TECHNICAL NOTE

Project Title: Beane Solar Farm

Report Reference: 794-PLN-TRP-JNY11727-04

Beane Solar Farm Technical Note

Appendix 3 – 17.8m Crane Swept Path Analysis

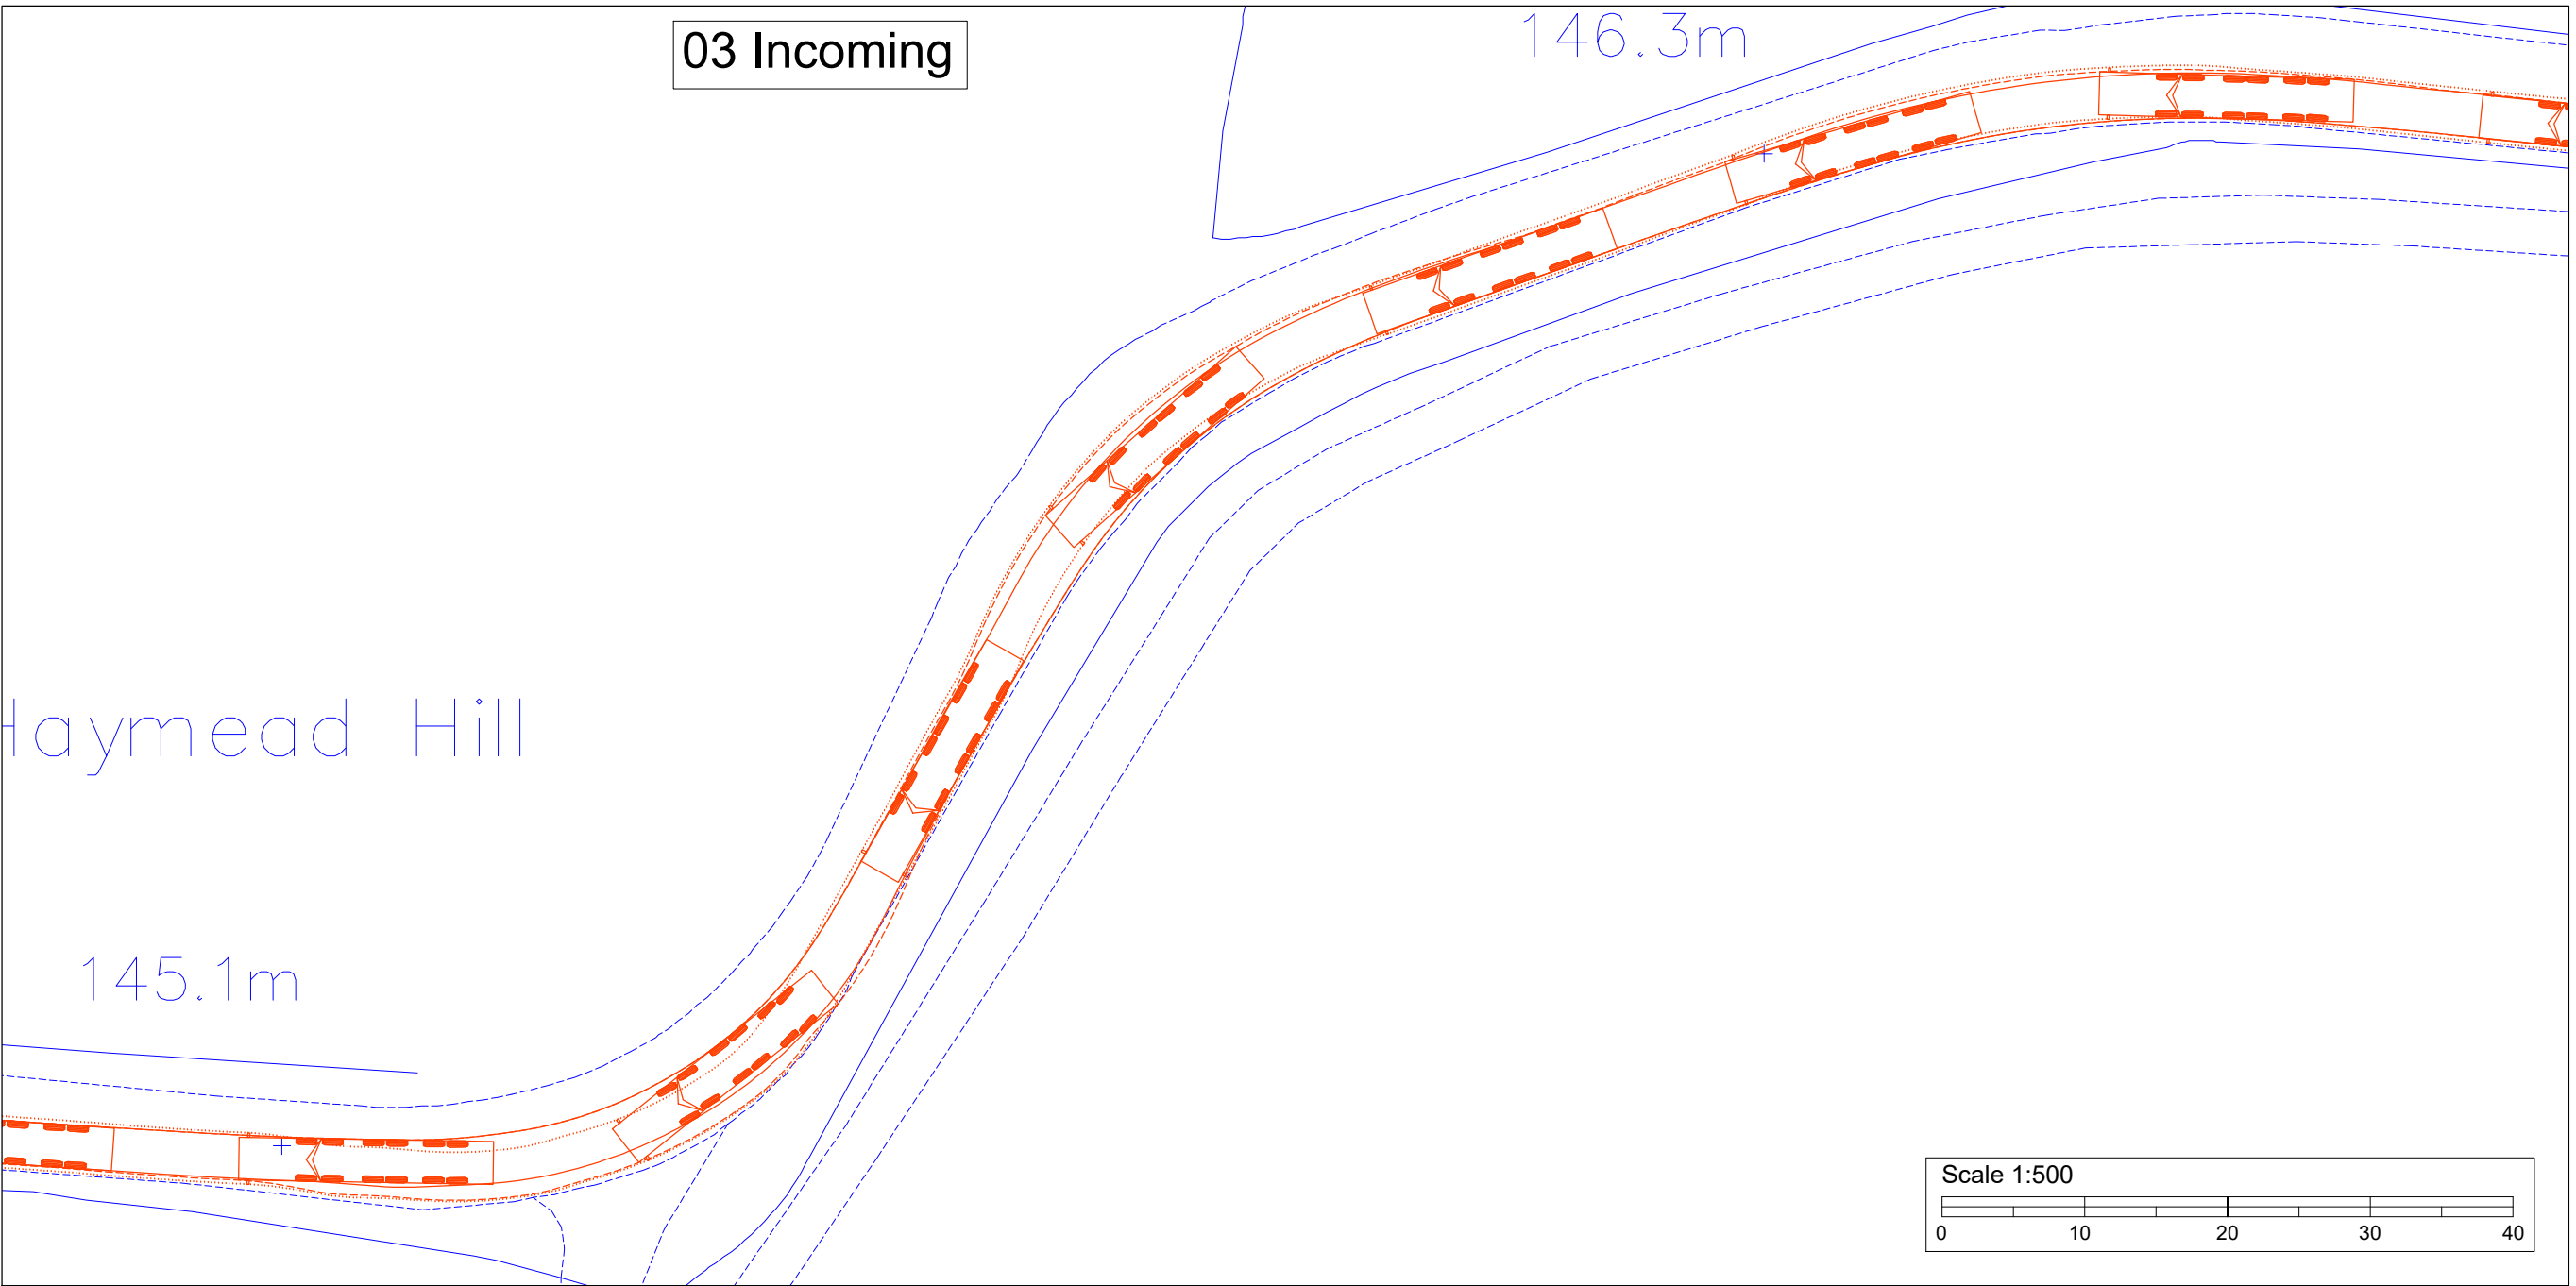
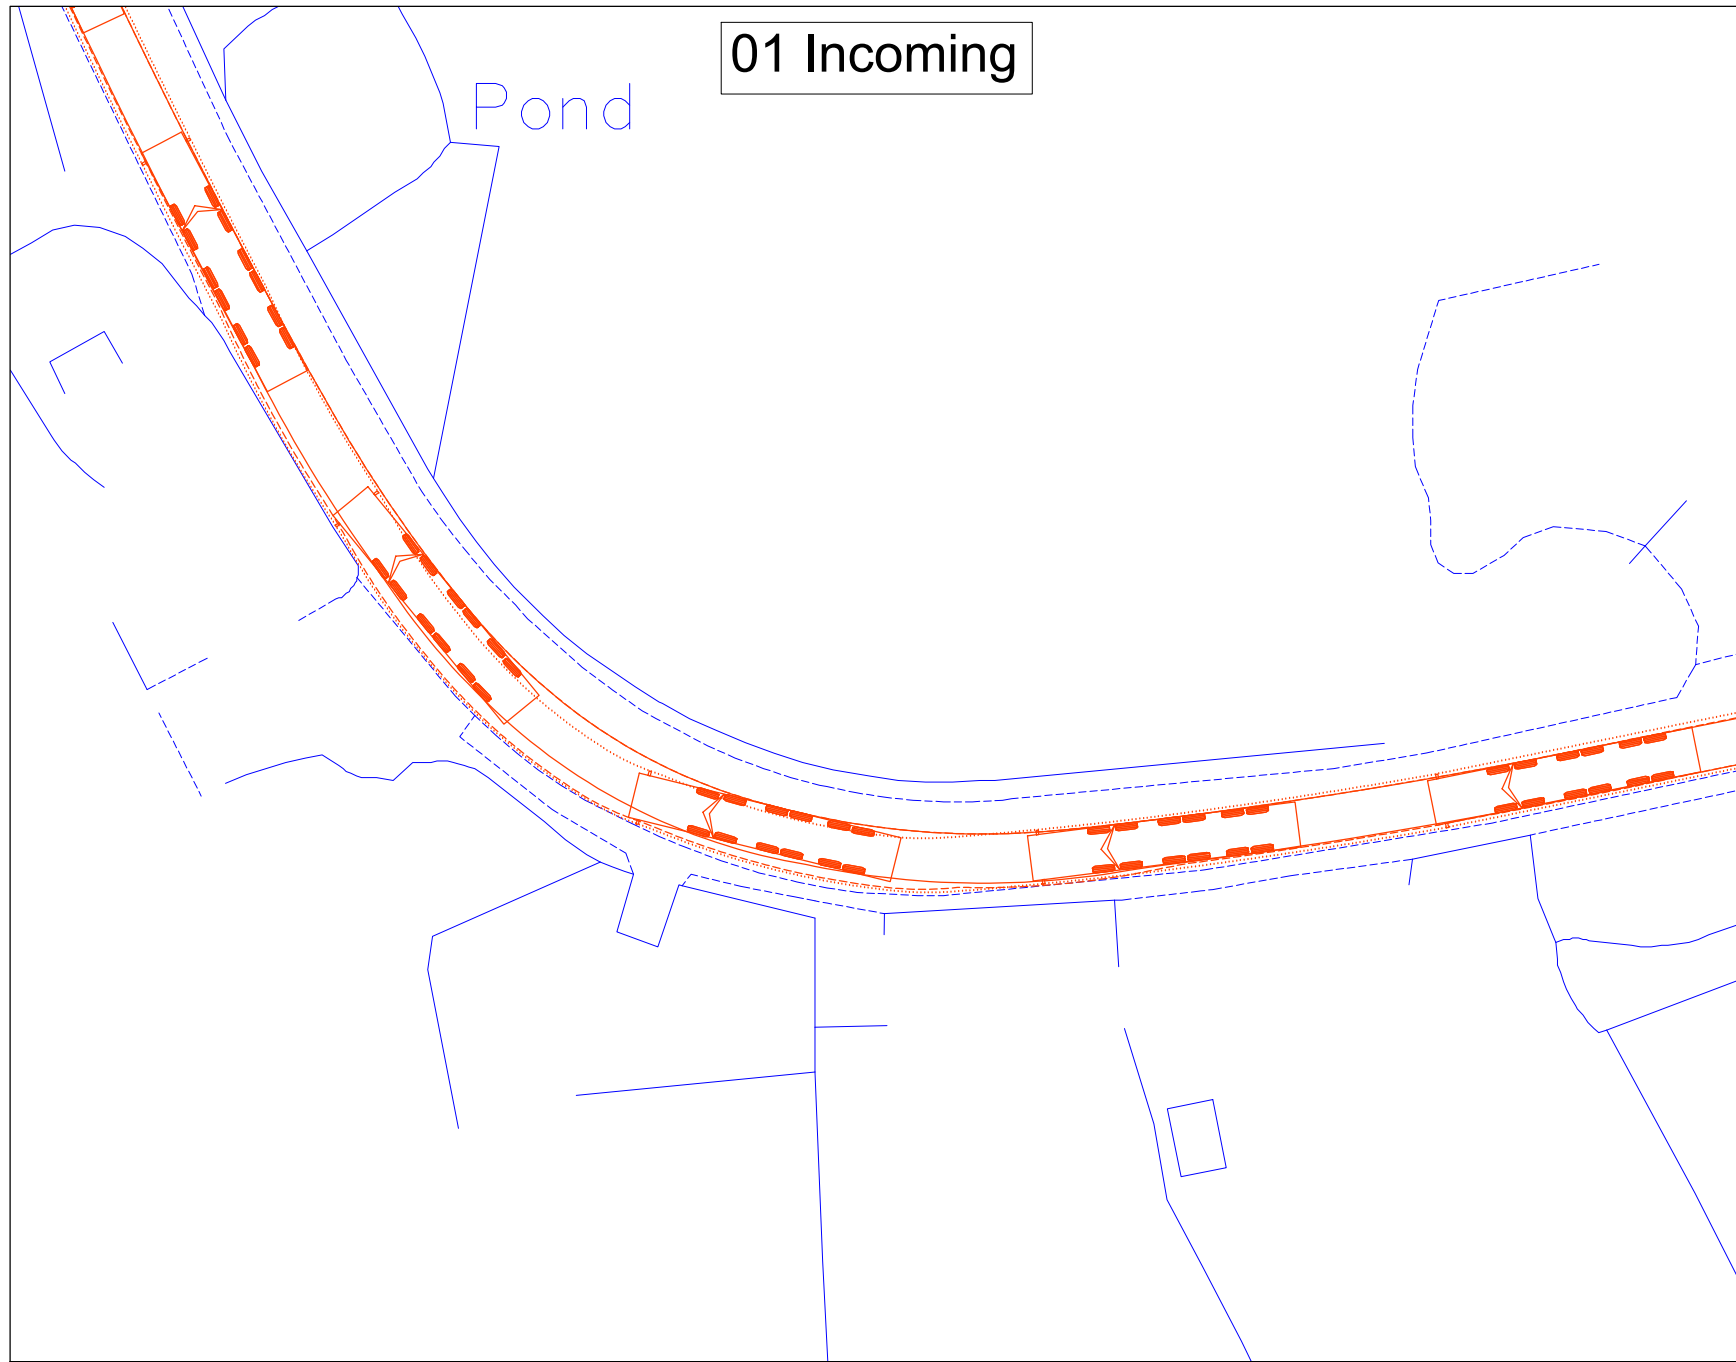
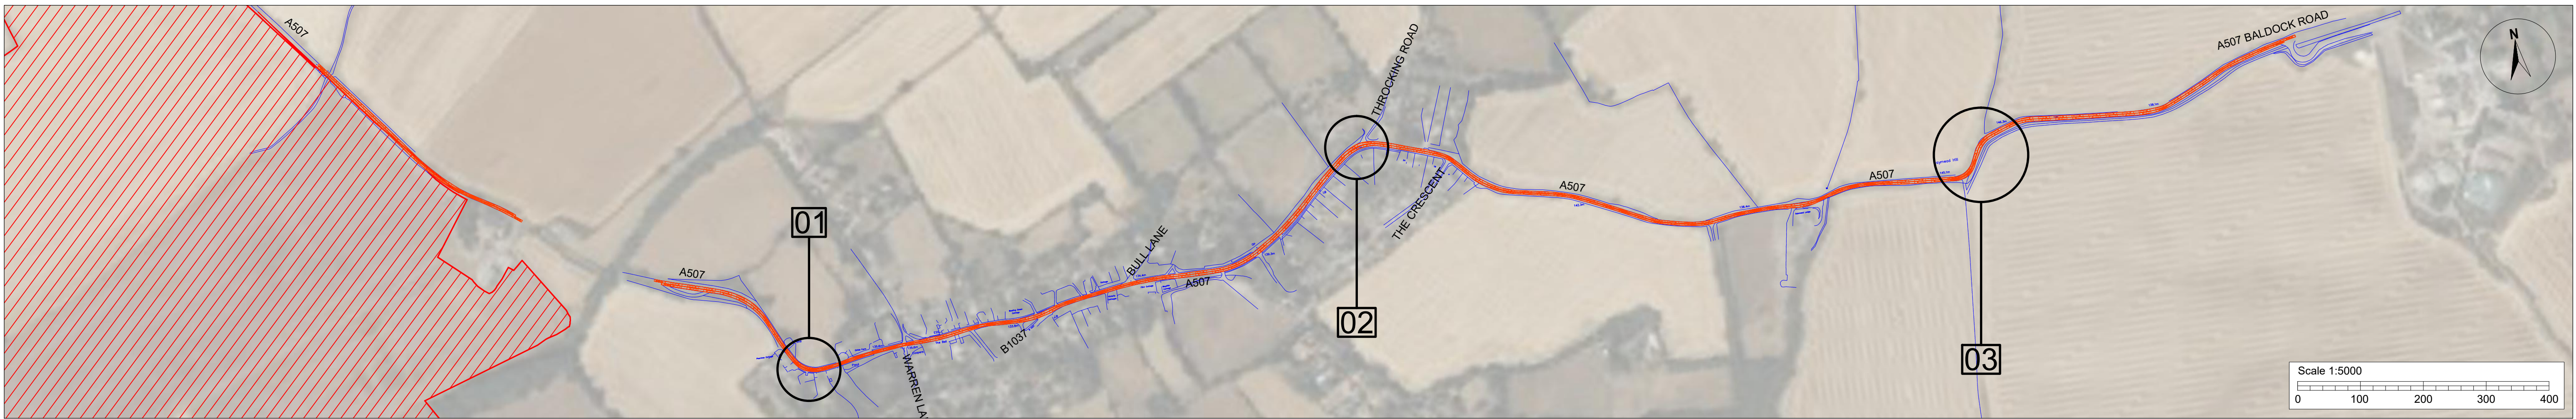
“- As per figure 3 the largest vehicle to the site will be a 17.8 metre crane which would need to be tracked using a swept path to ensure that it can reach and access the site.

- 1.25 A swept path analysis has been undertaken of a 17.8m crane accessing the site from the east via the A10, as this is the shortest route on the A507 of approximately 5.2km and a signposted route to the A10. This route also avoids Baldock to the northwest of the site. The swept paths are attached at **Appendix 3**, which demonstrate that a crane can travel safely along the proposed access route.
- 1.26 There will only be one entry movement, and one exit movement, of a vehicle of this size during the construction period.
